No.H8H+

H8H+ is the upgraded version of H8H series. The front & rear axles and the wheels are made of high-strength aluminium.
H8H+ 为H8H系列升级版本。前后桥、轮毂均使用高强度铝合金材质。

Upgraded parts relative to the H8H are as follows:
相对于H8H升级部件如下：

OP-8HS

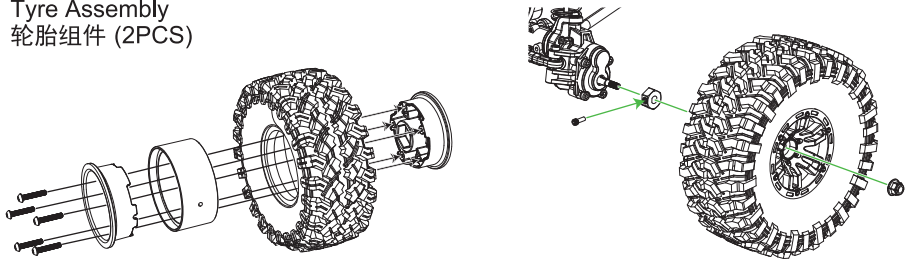
- ⚠ *OP-8HS is assembled in a similar way as H8H, please refer to the H8H manual exploded view for disassembly and maintenance. However, please note that the front & rear axle cabins are not common. Please pay attention to the difference.*
OP-8HS装配方式与H8H类似，拆卸保养时请参考H8H说明书爆炸图。但是请注意，前后桥箱不通用。请注意区分。

⚠ *OP-8HS is sold as a complete kit only, the following accessories for the original H8H front and rear axles: P8HSA01, P8HSA02, P8HSA03, P8HSA04, P8HSA07 cannot be mixed.*
OP-8HS仅作为整装配件出售，原有H8H前后桥的以下配件：P8HSA01、P8HSA02、P8HSA03、P8HSA04、P8HSA07无法混合使用。

OP-T2202

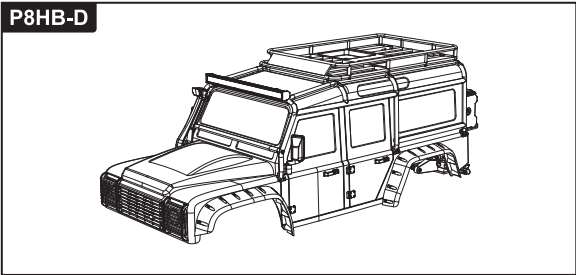
- ⚠ *The body assembly matching spare wheel hub uses a plastic wheels, the same as the H8H series body assembly. Tyre assembly No: PT2201.*
车壳配套备胎轮毂使用塑胶轮毂，与H8H系列车壳相同，编号为：PT2201。
